New Project Proposal: SFF-8614

Presented: February 9, 2024

New Project Proposal: SFF-8614, updates to Rev 3.5

(Drawing view taken from Figure 7-1)

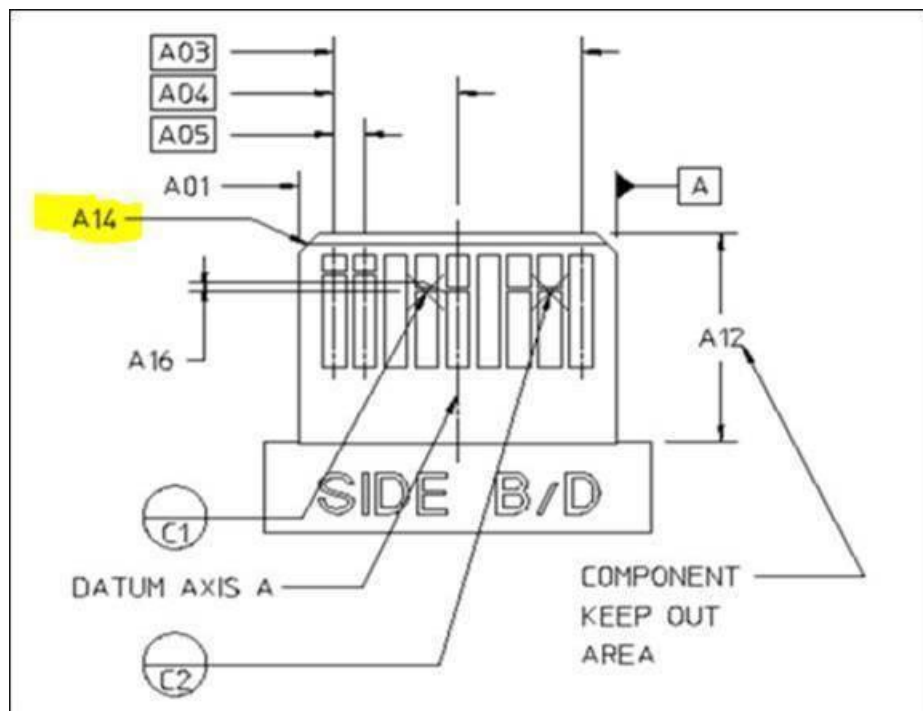
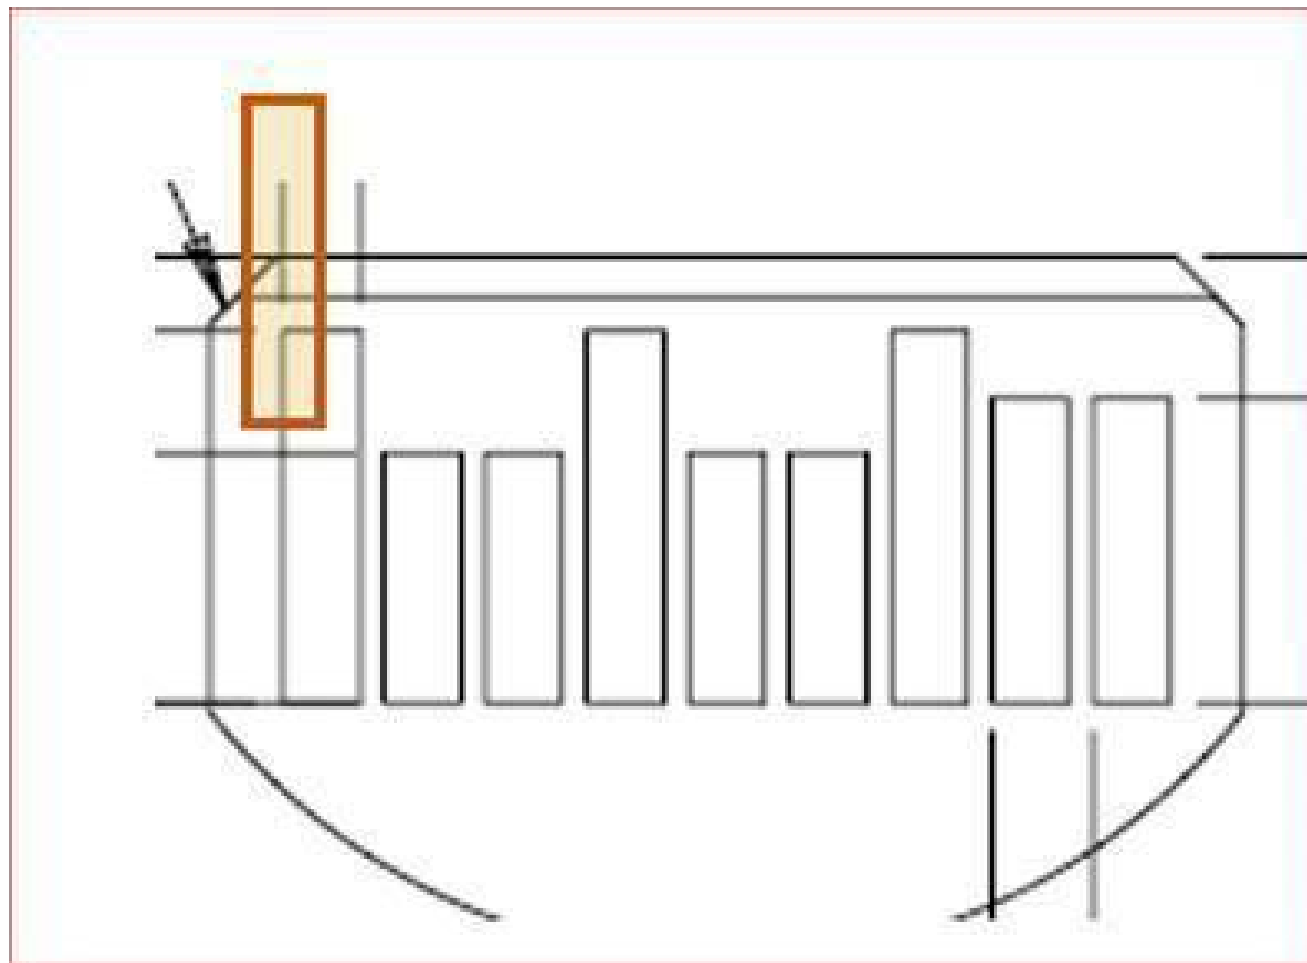
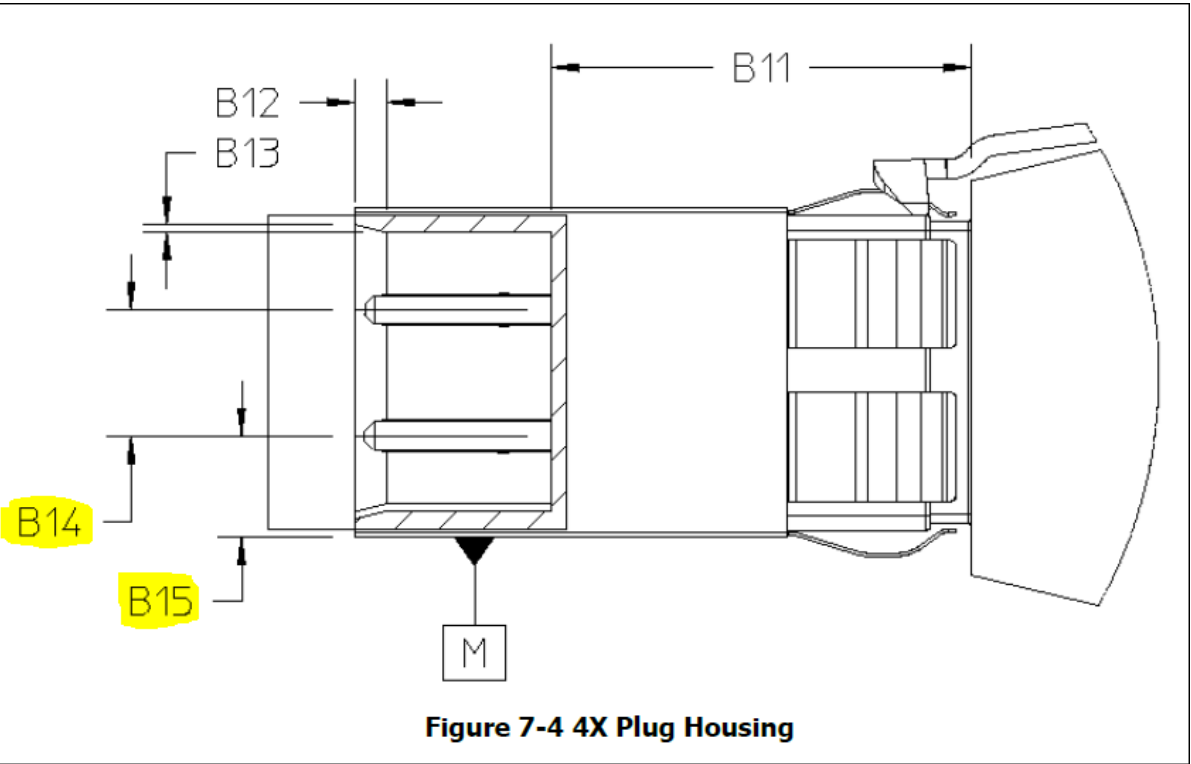
- Over the years, occasional quality issues have come up where the contacts at the extreme left or right positions within the MiniSAS HD receptacle may get damaged during the mating process. The receptacle contacts are specified to be located within a specific zone. If these outside edge contacts happen to be located at the very edge of that specified zone, then there is a small chance that the contact may come in contact with the mating plug paddle card right at the corner chamfer and potentially get skewed to the side by the chamfer instead of riding straight up the leading edge chamfer. This can cause damage to the receptacle contacts at the outside edges of the connector. It is not desirable to have to deal with any damage to the receptacle connectors since replacing damaged ones in a system can be very expensive. It is easier to modify the mating plug dimensions. To prevent this rare damage condition from happening, we propose to reduce the size of the plug paddle card's corner chamfer, dimension A14, from $0.50 \pm 0.05 \times 45^\circ$ to $0.30 \pm 0.05 \times 45^\circ$. See the next few slides for further details.

The A14 chamfer in question, from Figure 7-1 & Table 7-1, is highlighted in the images below ...

Here is a view showing the MiniSAS HD receptacle contact zone (where the contact must be located within this zone) overlaid on top of the mating plug paddle card's corner chamfer's current size and location.

Figure 7-6 4X Plug Latch Stop to Contact

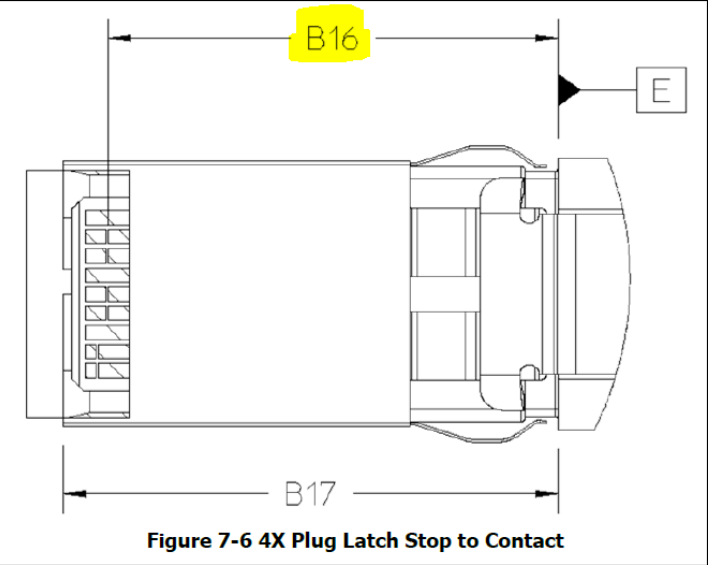
Some various dimensions in question (among others), from Figure 7-6, Figure 7-9, & Figure 7-1, and the associated tables, are highlighted in the images below ...

The exact dimensional improvements to be made are to be determined and should be dependent on targeting potential simulated or measured SI improvements.
